AGENDA
REGULAR MEETING OF THE BIRMINGHAM PLANNING BOARD
THURSDAY, SEPTEMBER 23RD, 2021
151 MARTIN ST., CITY COMMISSION ROOM 205, BIRMINGHAM MI *
*****7:30 pm*****

- E. Unfinished Business
 - 1. **34745 Woodward – Jax Kar Wash** – Request for Final Site Plan and Design Review for circulation, layout and minor building changes to the existing site.

SUBJECT: 34745 Woodward – Jax Kar Wash – Final Site Plan & Design Review

AS100

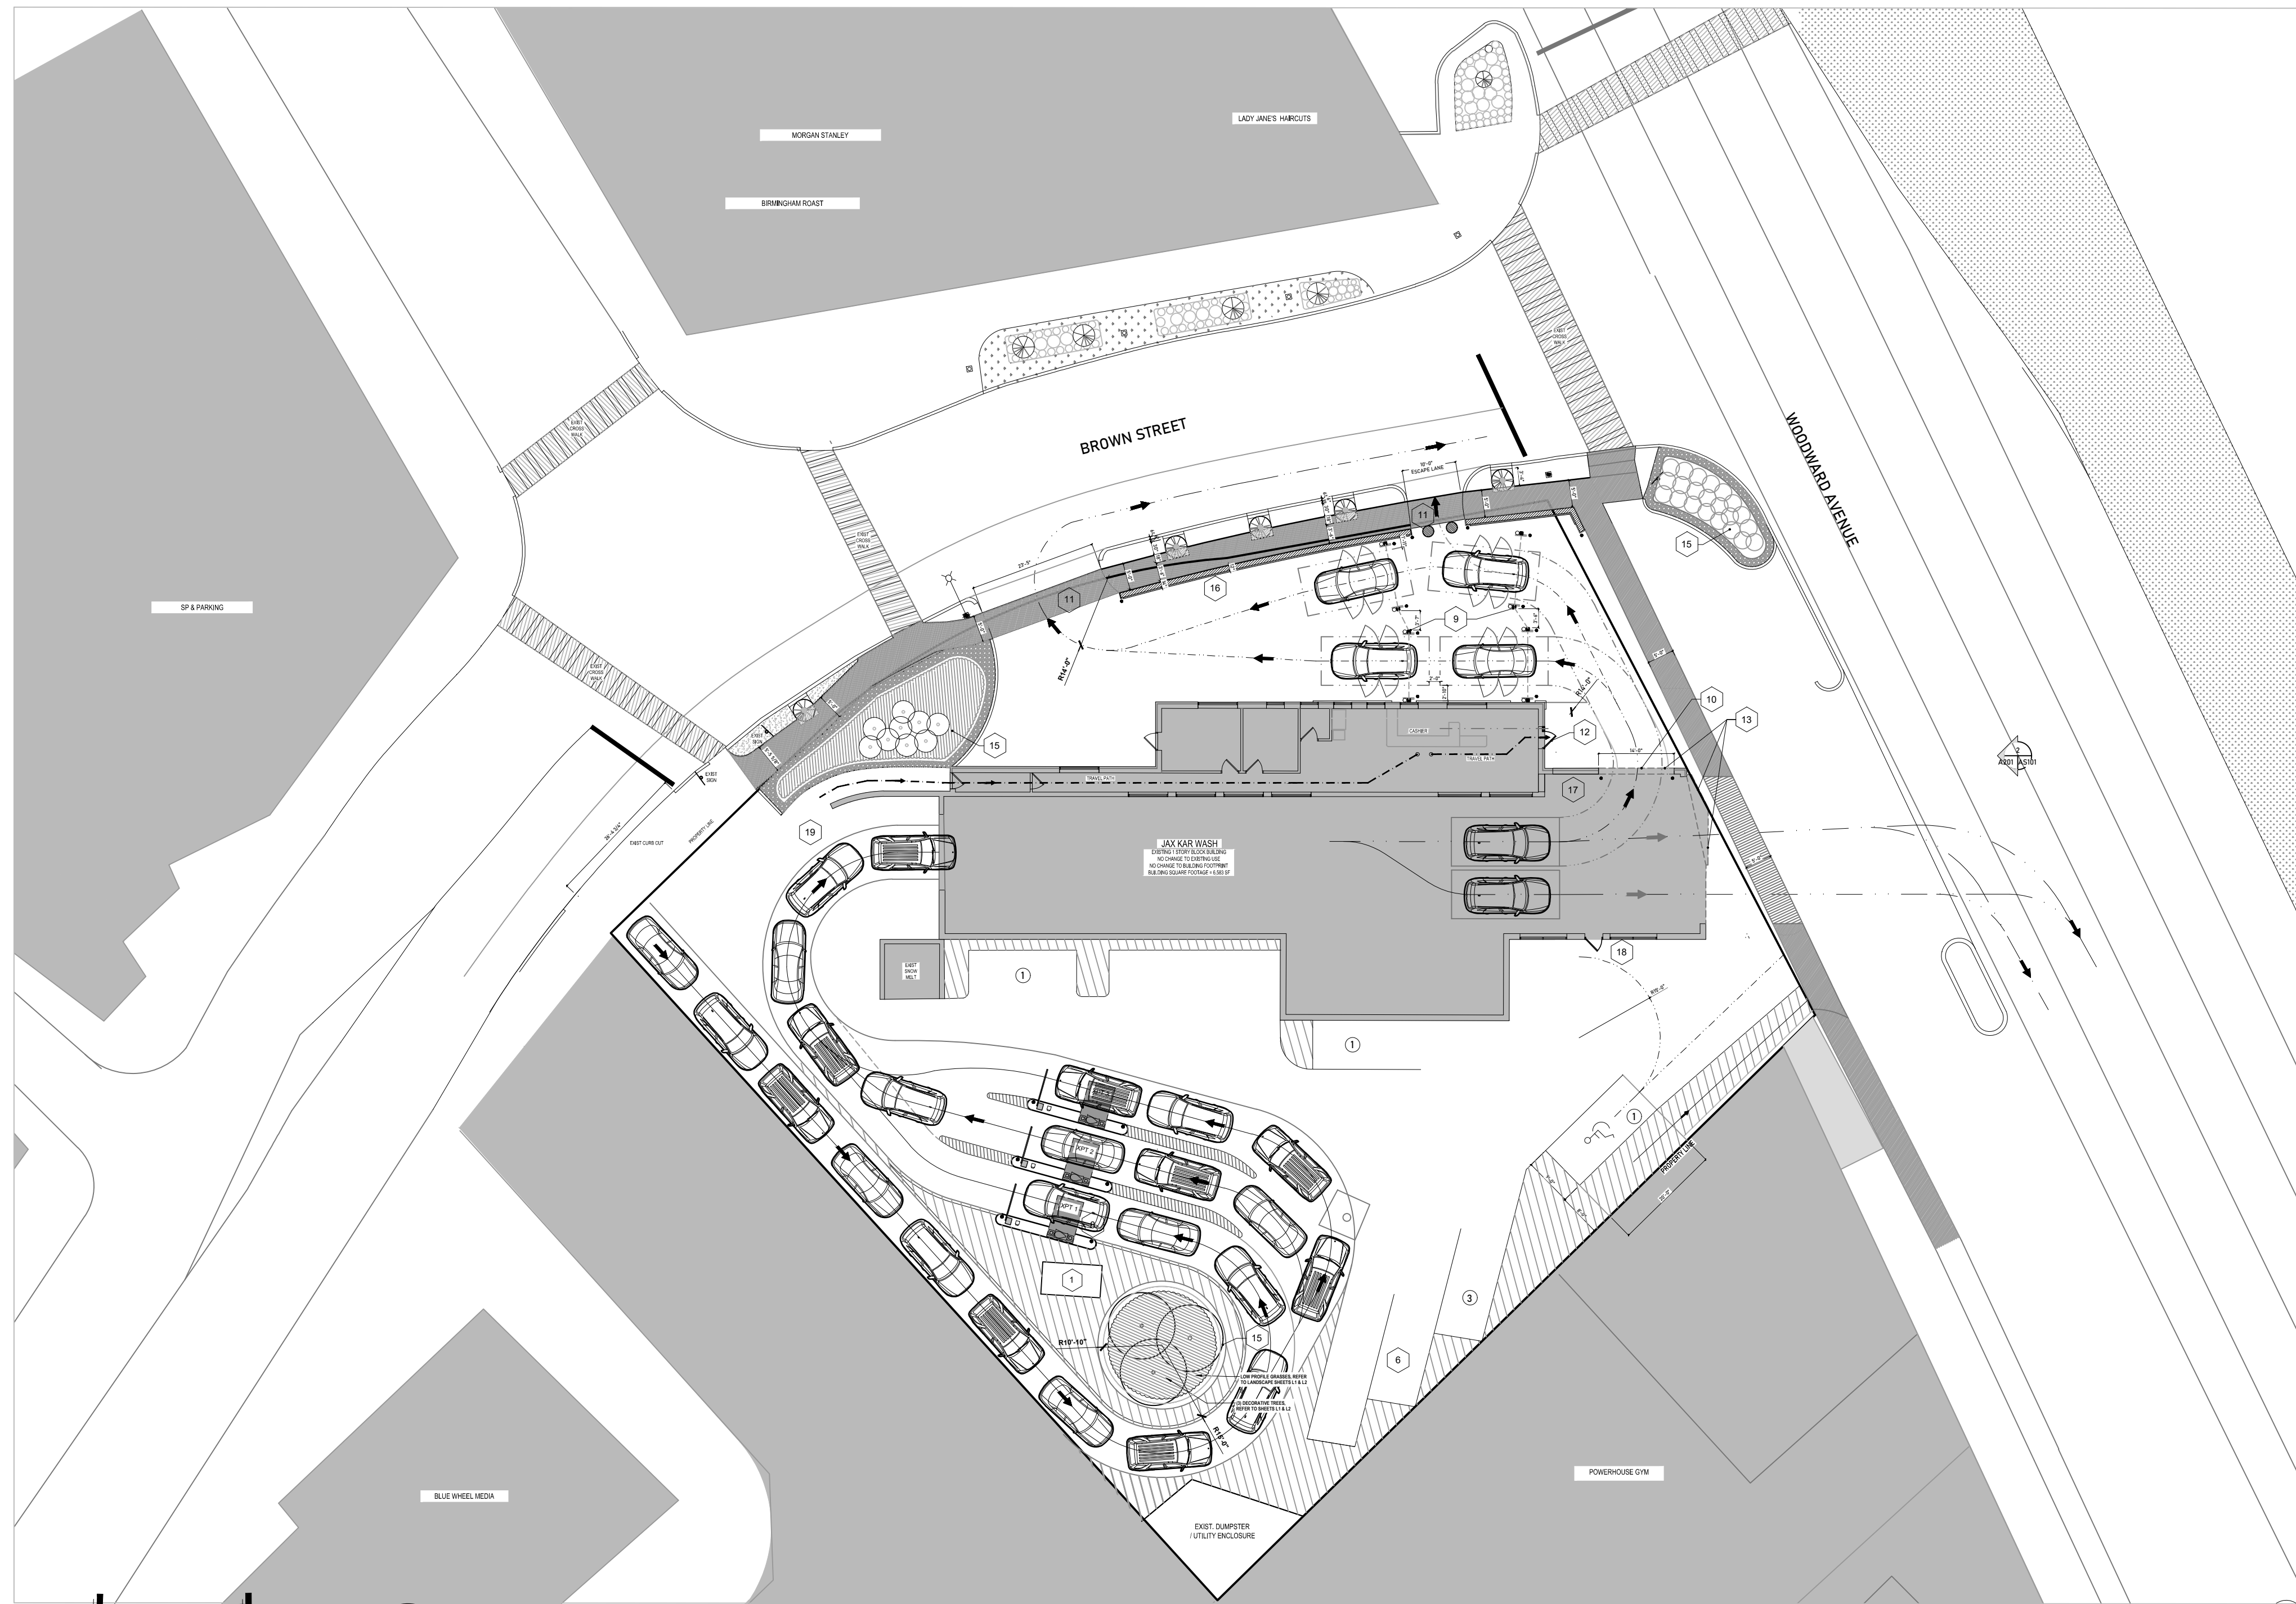
At this time, the applicant is proposing roughly 90 ft. of 32 in. high masonry screen wall with brick veneer spanning a portion of Brown St. and the northeast corner along Woodward. The screen wall contains a break at roughly 55 ft. which has been supplemented by two planters. This break is also related to a new proposed curb cut that is describes as an escape lane onto Brown St. There are several concerns related to parking lot screening on site:

First, the required break does not appear to meet the requirements of Section 4.54 (B), as the proposed break does not contain a screen wall with a permitted material, nor do the proposed planters sit 2 ft. to either the front or the rear of the principal screen wall. The permitted materials for screen wall breaks are a masonry wall with an exterior face of brick, precast aggregate panels, sculptured block, stone, architecturally treated concrete or other materials acceptable to the Planning Board, which are demonstrated to be durable, easily maintained, and provide a similar permanent visual barrier. **The Planning Board may wish to discuss whether the proposed planters are a screening material that is acceptable or not.**

Due to the issues noted above, **the applicant must submit revised plans with sufficient screening that meets Article 4, Section 4.54 of the Zoning Ordinance or obtain a variance from the Board of Zoning Appeals.**

However, the applicant is proposing 8 vacuum stanchions for detailing located on either side of the 4 stations on the north side of the building. Article 4, Section 4.54 (B)(8) requires all ground-mounted mechanical equipment to be screened with a masonry screen wall with wood gates. The screen wall is required to obscure the receptacle and equipment from public view. The vacuum stanchions are 40 in. in height. The proposed 32 in. parking lot screen wall does not sufficiently obscure the vacuum stanchions from public view and thus, **the applicant must provide additional screening for the mechanical equipment on the north side of the building, or obtain a variance from**

1. The applicant must submit revised plans with sufficient screening that meets Article 4, Section 4.54 of the Zoning Ordinance or obtain a variance from the Board of Zoning Appeals;
2. The applicant must provide additional screening for the mechanical equipment on the north side of the building, or obtain a variance from the Board of Zoning Appeals;
3. The applicant must submit a consistent and detailed sign plan including all building signs and accessory signage to complete the Design Review;
4. The applicant must comply with the requests of all City Departments.

2
A200
PROPOSED NORTH ELEVATION (BROWN ST.)

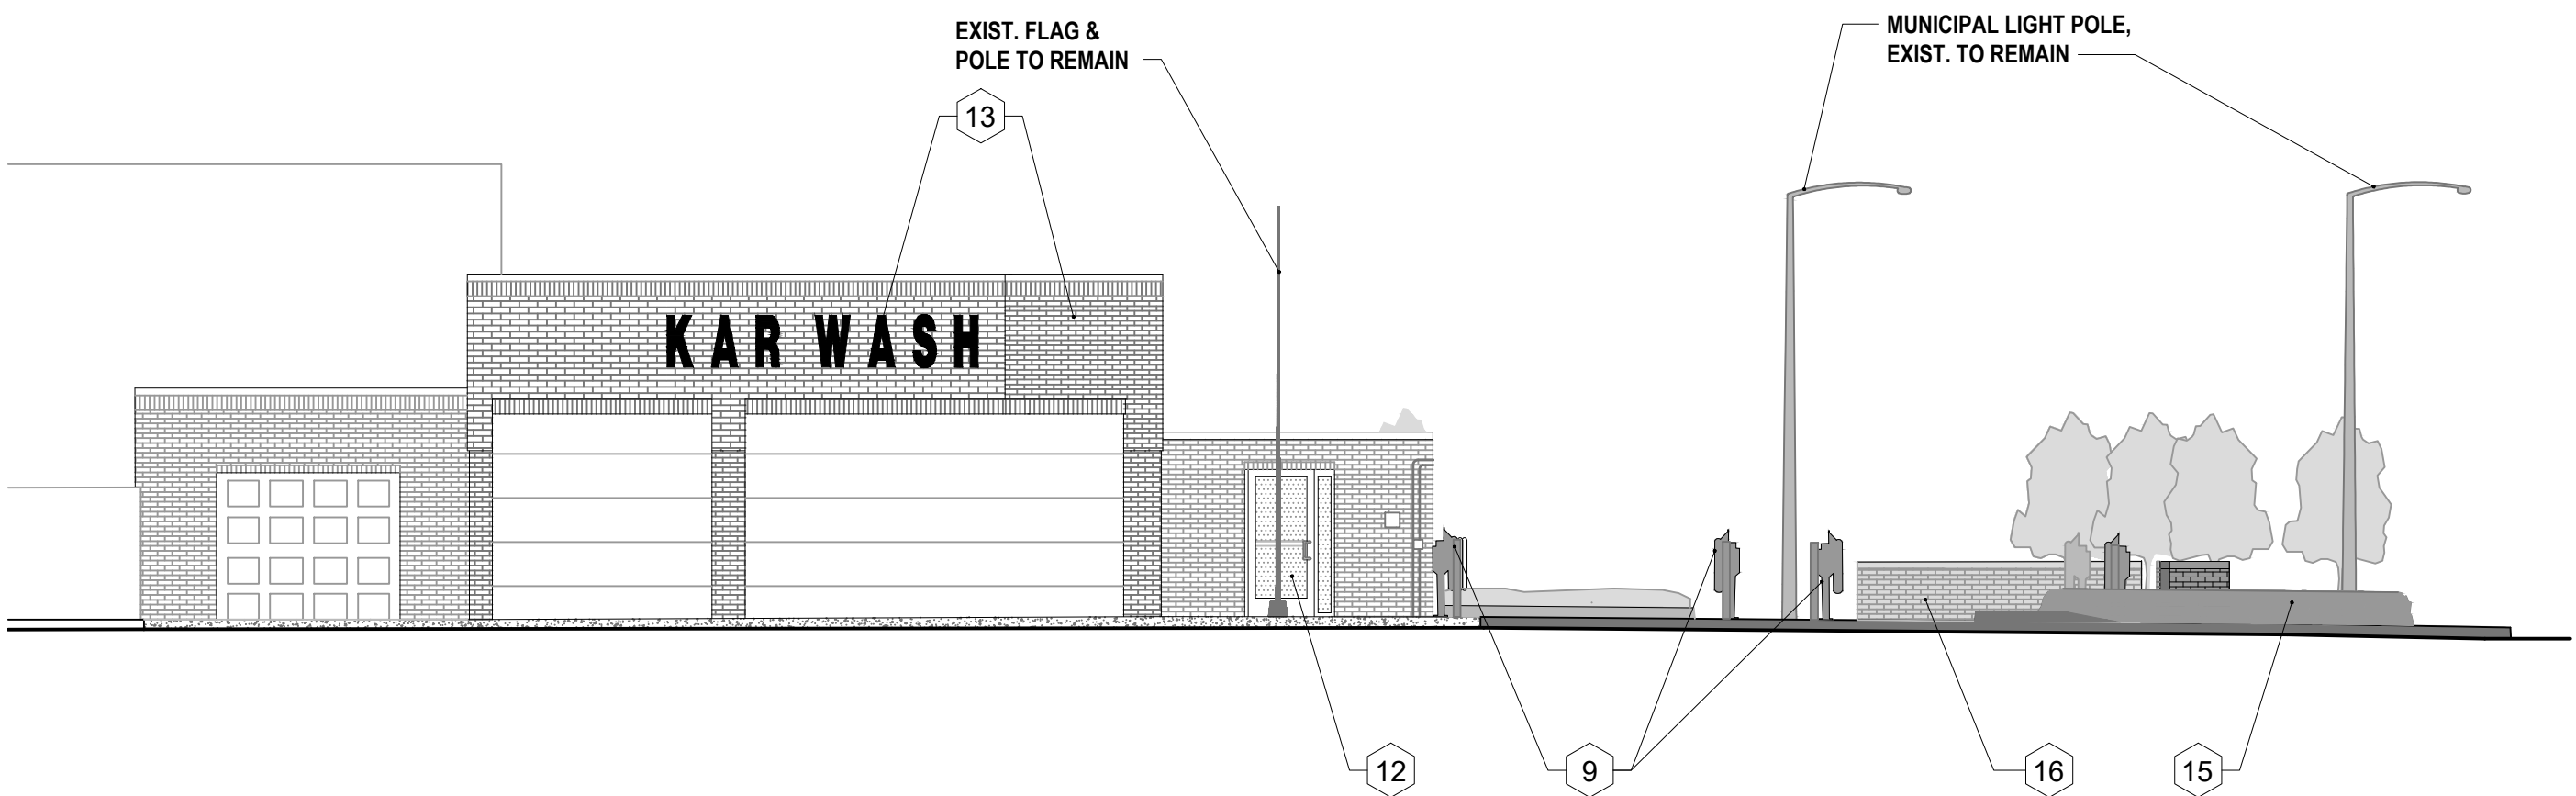
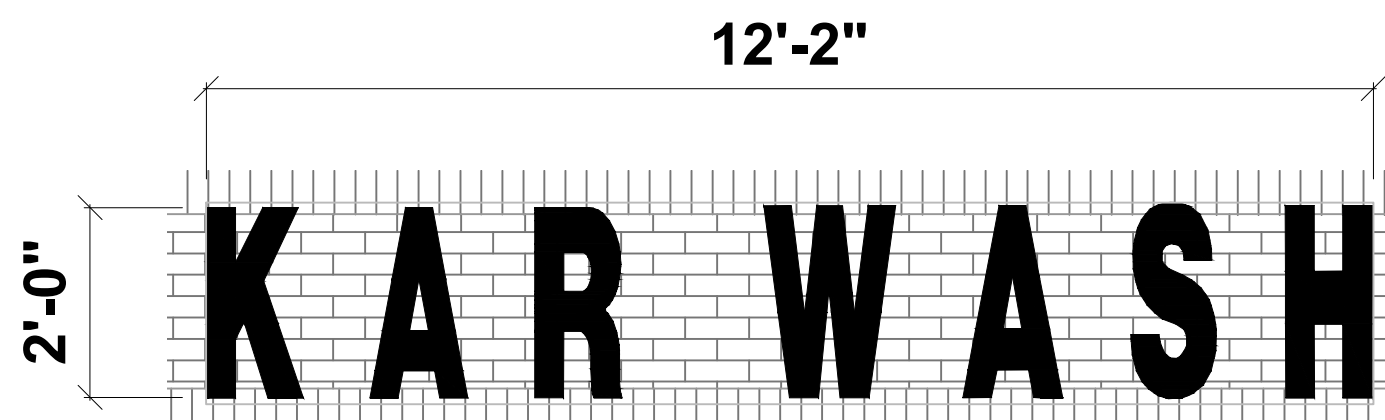
The Sign Ordinance requires that combined sign area be calculated based on the principal building frontage, which is defined as the width of the building on the side where the primary entrance to the business is located, which may or may not front a street. The Planning Board may designate an alternate horizontal building width as the principal building frontage for signage purposes. The primary entrances are along the Woodward frontage (pedestrian) and along the rear of the building (vehicular). The applicant has requested and has designed signage using the Brown St. horizontal building width as their frontage, in which the applicant is permitted a combined sign area of 1.5 square feet per each linear foot of principal building frontage (135 linear feet). The applicant is proposing 191.2 square feet of building signage where 202.5 square feet would be permitted if the Brown St. frontage were designated. **The Planning Board should discuss whether the Brown St. frontage should be designated as the principal building frontage for signage purposes or not.**

Furthermore, although the applicant has submitted content and area details of the main building signage, the plans do not contain other pertinent details such as projection from the building face, side profiles and materials. It is also apparent that there are other signs proposed across the site on the auto-attendant stations, as well as the vacuum stanchions. A sign is defined as any object, device, logo, display or structure, or part

thereof, which is intended to advertise, identify, display, or direct or attract attention to an object, person, institution, organization, business, product, service, event or location by any means. **The applicant must submit a consistent and detailed sign plan including all building signs and accessory signage to complete the Design Review.**
